## PLAN COMMISSION

September 10, 2019

**Proposal:** Plan Review – Screening Modifications for Edgewood Elementary School

**Proposal:** Plan Review – Site, Landscaping, and Screening Modifications for Meadowview Elementary School

DRAWING TITLE  
**LANDSCAPING PLAN**

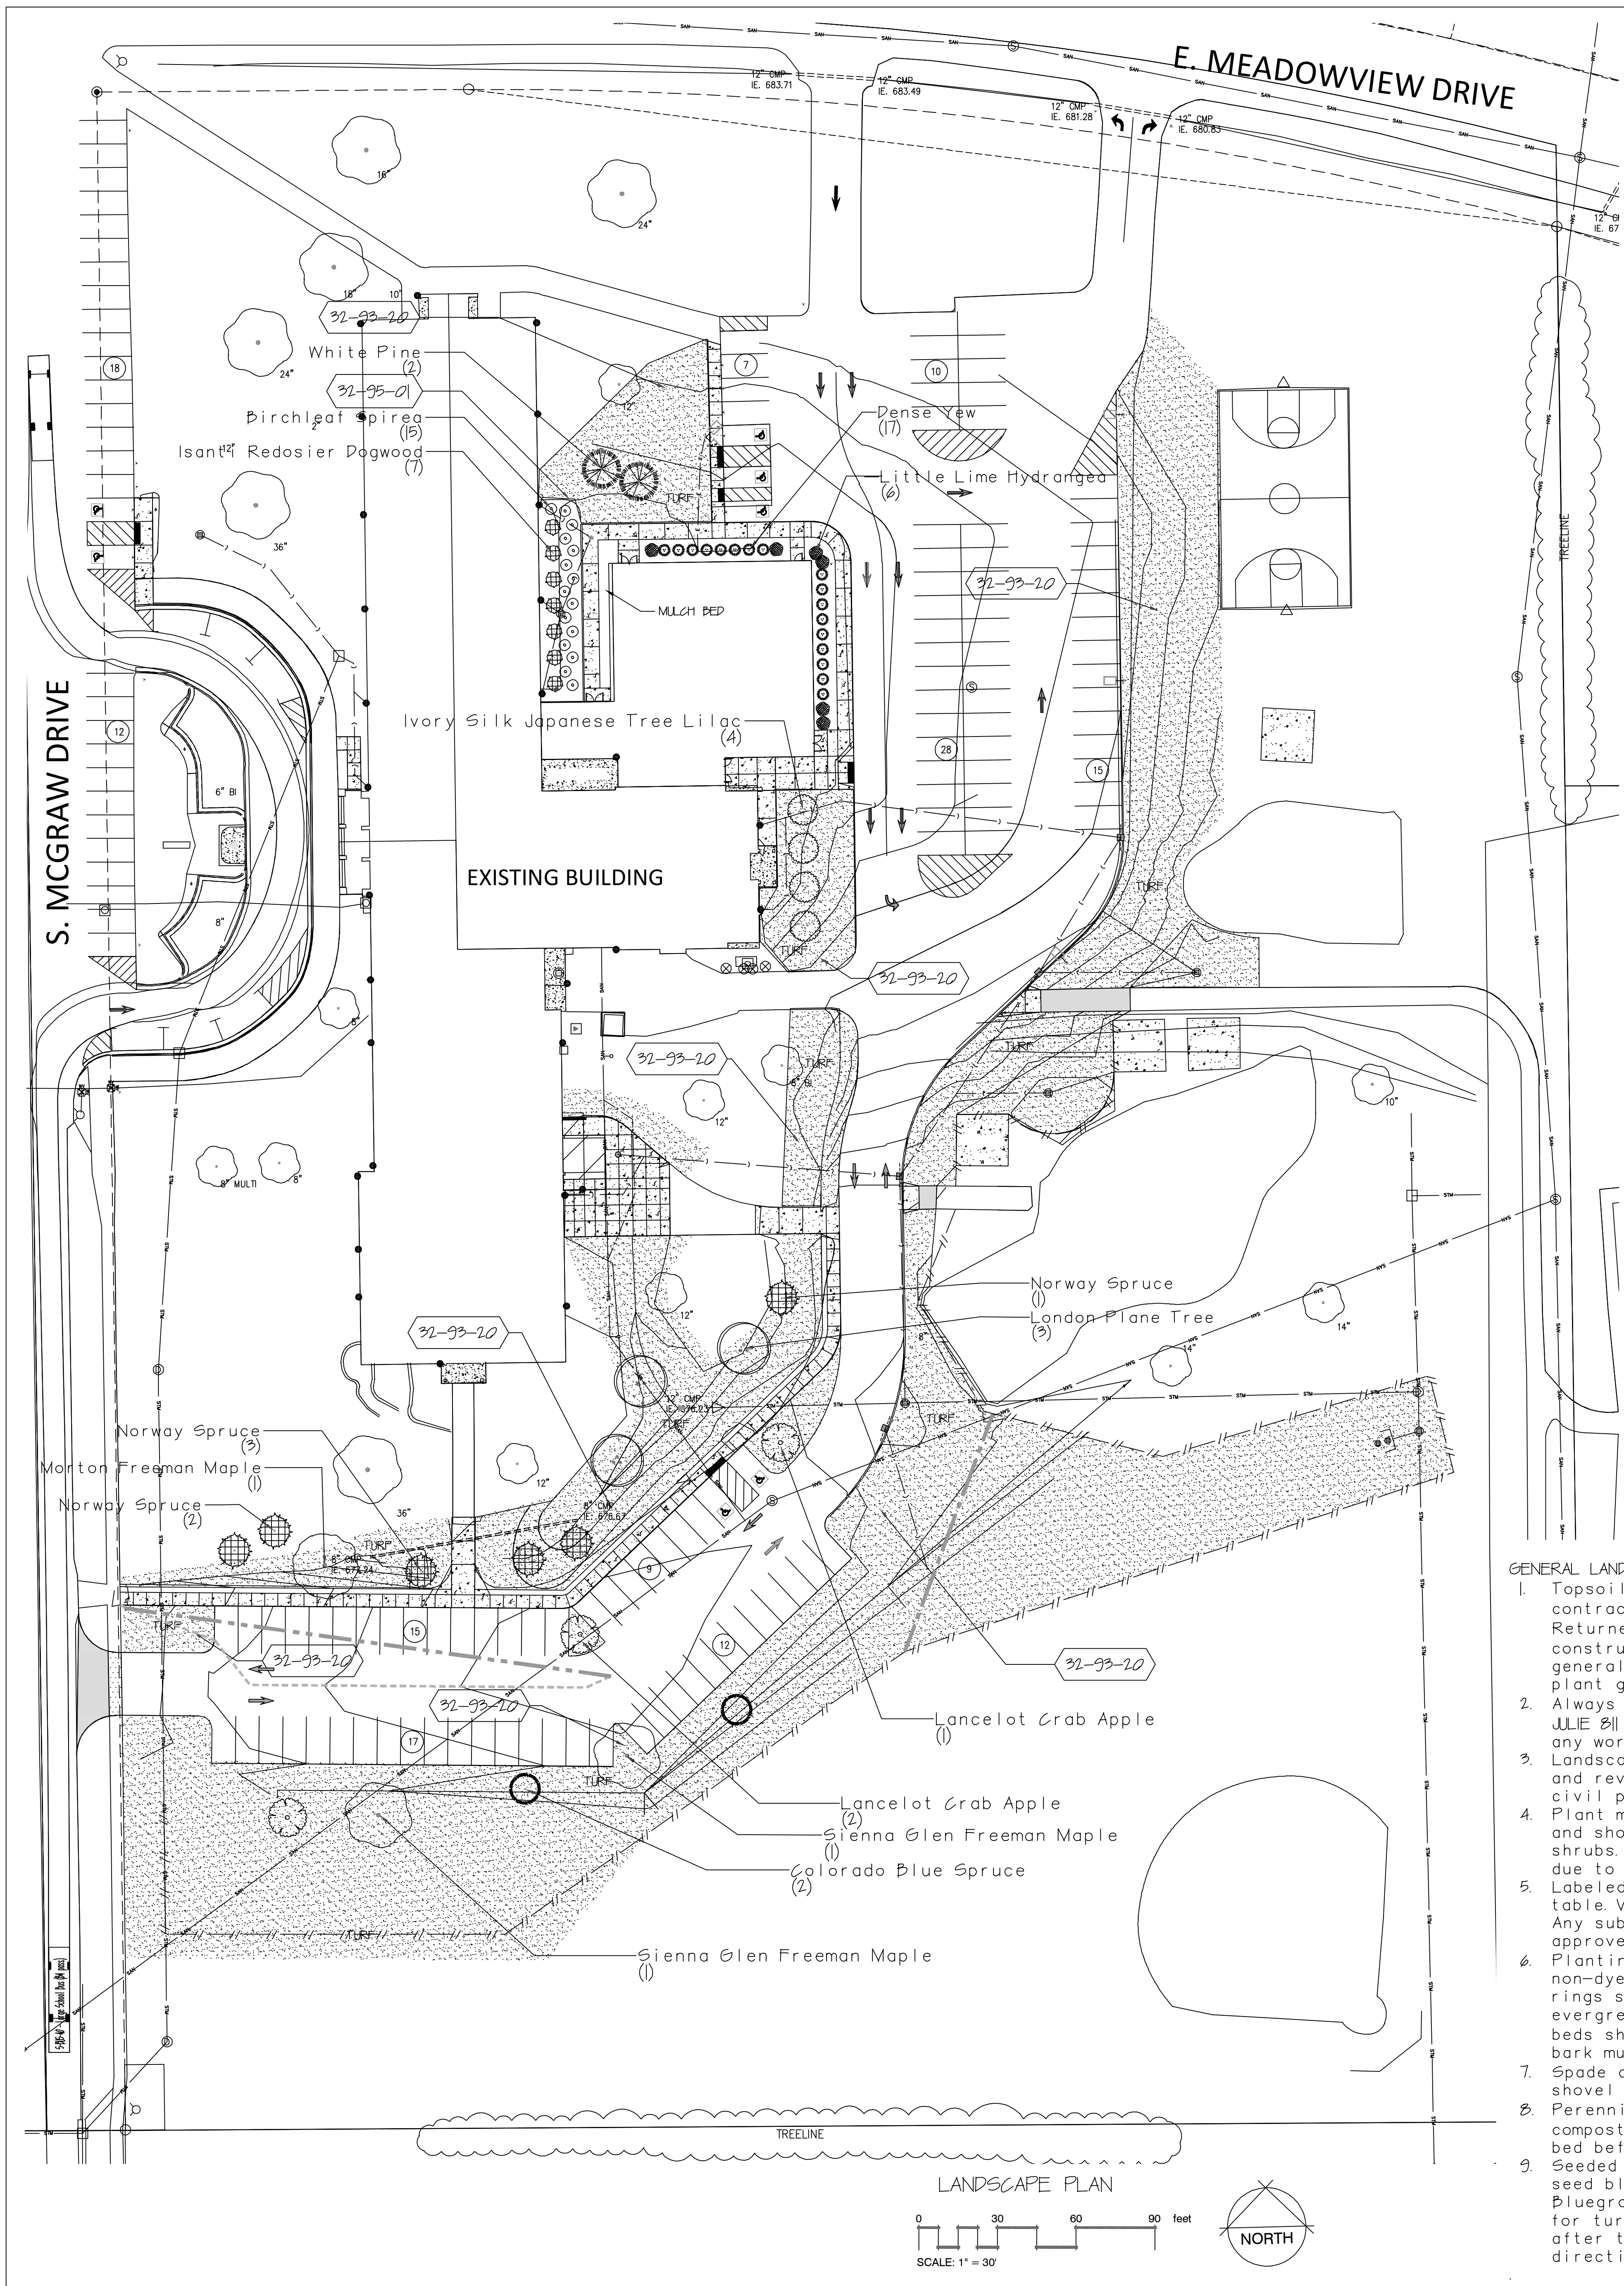
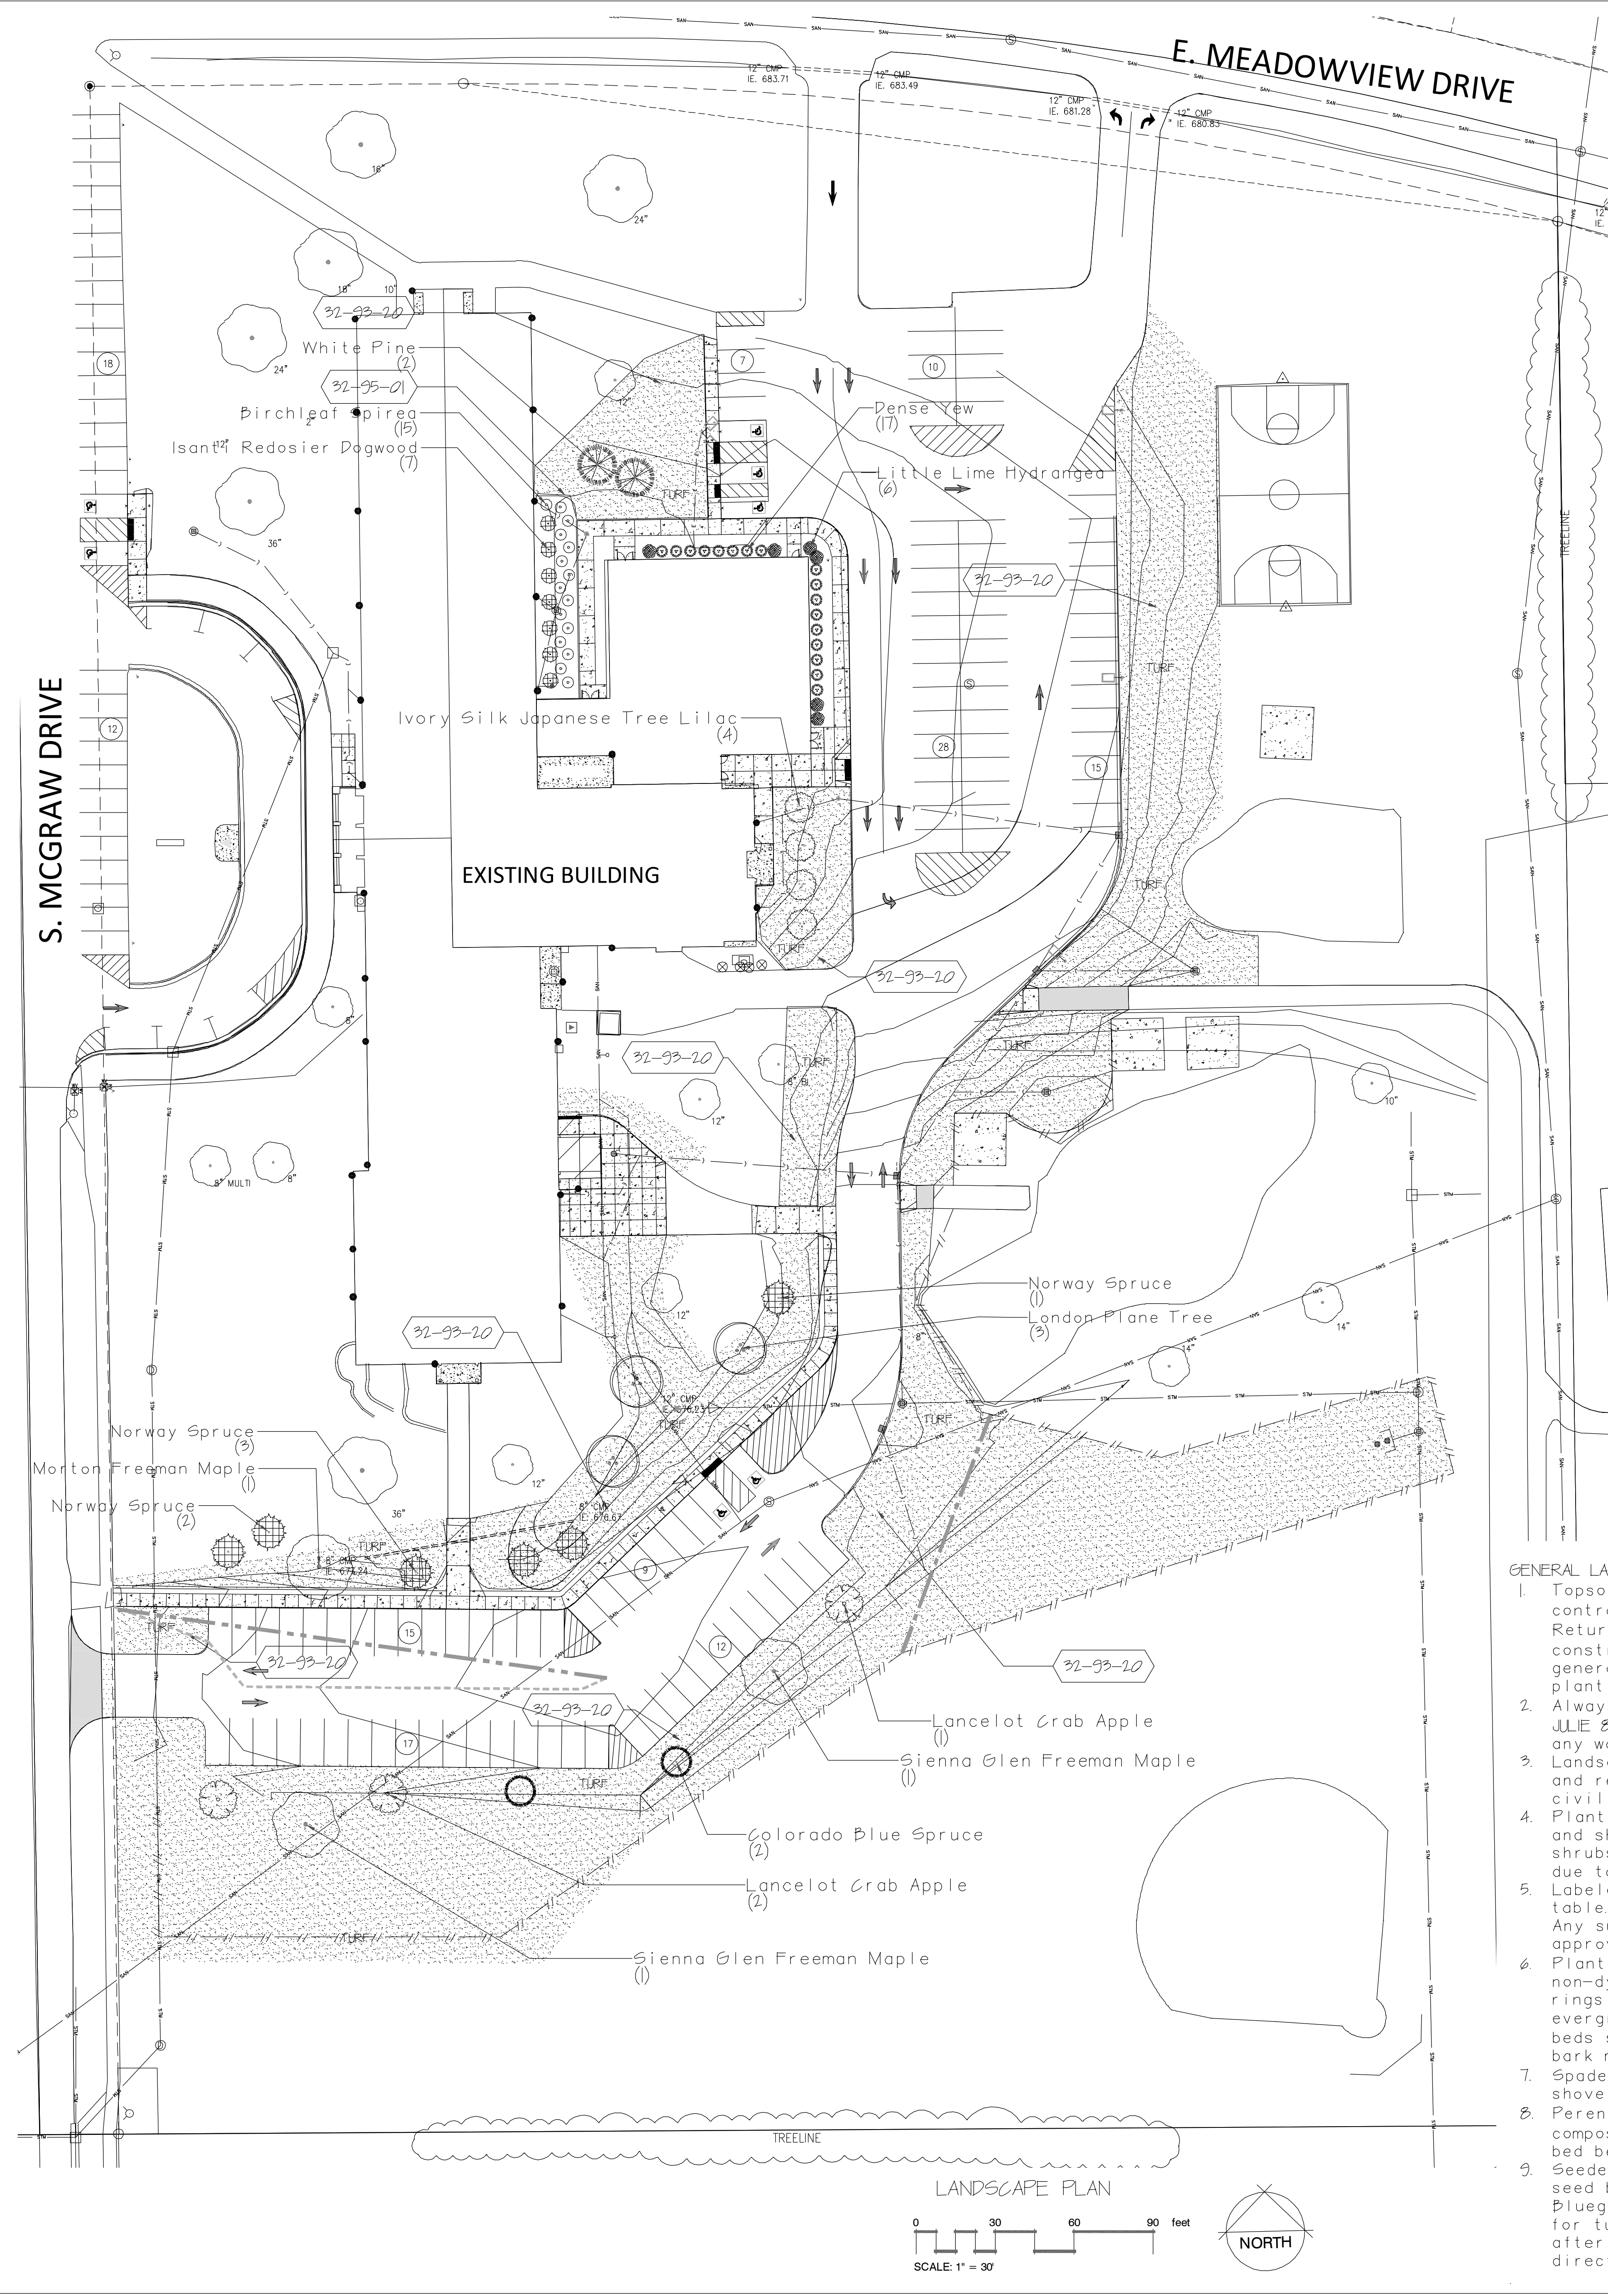
Parking lots are required to incorporate landscaping whether new or expanded. Specifically, for any public offstreet parking area serving at least 25 vehicles, “at least one-half of the minimum five (5) percent landscaped area shall be within the parking lot.” While the landscape plan submitted for Plan Commission review at the March 12 meeting did not incorporate landscape islands, the approval was conditioned “That all relevant Code requirements remain in effect.” There was no modification request for landscaping submitted at the time of review. Further, the plans show that the proposed improvements are very close to the maximum impervious surface percentage allowed by Code. Staff have consistently included in Conditions of Approval for Plan Commission consideration that landscaping is installed per Code requirements, including in this case.

For the projects occurring this summer at Meadowview Elementary School, we respectfully request relief/variance for the islands in the new staff parking lot (South of the building). This lot was proposed without landscape islands to ease the snow plowing effort and minimize maintenance costs. The Site Plan did not include landscape islands when the Plan Commission approved the Site Plan at the March 12, 2019 Plan Commission meeting. The landscape islands were added to the Site Plan after City staff identified a code compliance issue during the Building Permit approval process.

The Oak Creek Franklin Joint School District is requesting that the Plan Commission approve the elimination of the landscape islands within the new staff parking lot.

1. That all relevant Code requirements remain in effect.
2. That all conditions of approval from March 12, 2019 remain in effect except as specifically amended herein.
3. That the proposed rooftop mechanical units are not required to be screened at this time; however, any changes to the rooftop mechanical units will require screening at the time of installation.
4. That the three (3) landscape islands in the south parking lot are not required to be installed at this time; however, any change(s) to the parking area will require landscaping in conformance with Code requirements in effect at the time of the change(s).
5. That all detailed, revised plans are submitted in digital format to the Department of Community Development prior to submission of permit applications.
